Access Compliance Report

Public Rights-of-Way

Intersection ID: 3270	Main Street: BATTLE_CREEK_CT	Cross Street: OLD_TIMBER_RD	Location: S
ADA ID: 9E44062EC73F	Ramp Type: Perp	Initial Pass/Fail: Fail	Overall Compliance: No
Severity Score: 22.5			
Codes/Mitigation Info/Possible Solution		Field Measurements/Component Compliance

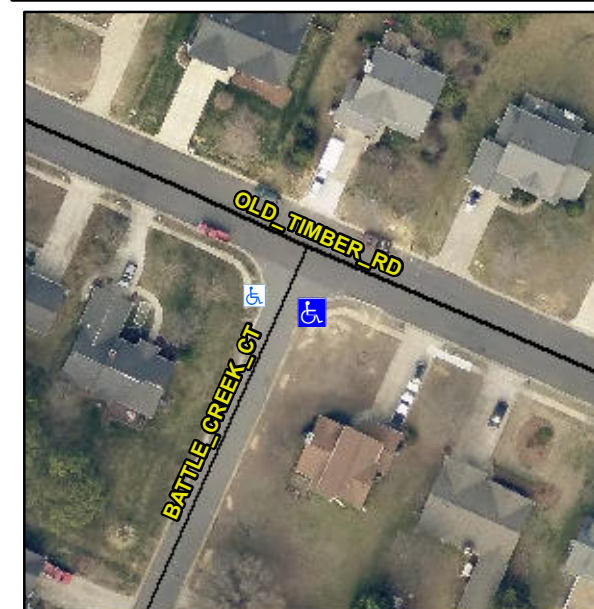
Not Found, R304.5.1, R304.2.2, R304.5.3

Compliance	Description	Data	Compliance	Description	Data
N/A	Ramp Length (in)	57.0	No	Ramp Slope (%)	8.7
No	Ramp Width (in)	39.0	No	Ramp XSlope (%)	4.1
N/A	Flare Type LT	N/A	N/A	Flare Type RT	N/A
N/A	Flare Slope LT (%)	N/A	N/A	Flare Slope RT (%)	N/A
N/A	Flare Traversable LT?	N/A	N/A	Flare Traversable RT?	N/A
N/A	Landing Length (in)	N/A	N/A	DWS Provided?	N/A
N/A	Landing Width (in)	N/A	N/A	DWS Contrast?	N/A
N/A	Landing Slope (%)	N/A	N/A	DWS Length (in)	N/A
N/A	Landing X Slope (%)	N/A	N/A	DWS Full Width?	N/A
N/A	Landing Curb? (Y/N)	N/A	N/A	DWS Offset (in)	N/A
N/A	Shared Landing?	N/A			
N/A	Gutter Ponding?	N/A	N/A	Gutter Slope (%)	N/A
N/A	Gutter Lip Ht (in)	N/A	N/A	Gutter X Slope (%)	N/A
N/A	Painted X Walk1?	No	N/A	Painted X Walk2?	N/A
	X Walk 1 Direction	To NW		X Walk 2 Direction	N/A
N/A	X Walk 1 Width (in)	N/A	N/A	X Walk 2 Width (in)	N/A
	X Walk 1 Slope (%)	4.2		X Walk 2 Slope (%)	N/A
	X Walk 1 X Slope (%)	3.3		X Walk 2 X Slope (%)	N/A

Remove & Replace Entire Ramp.
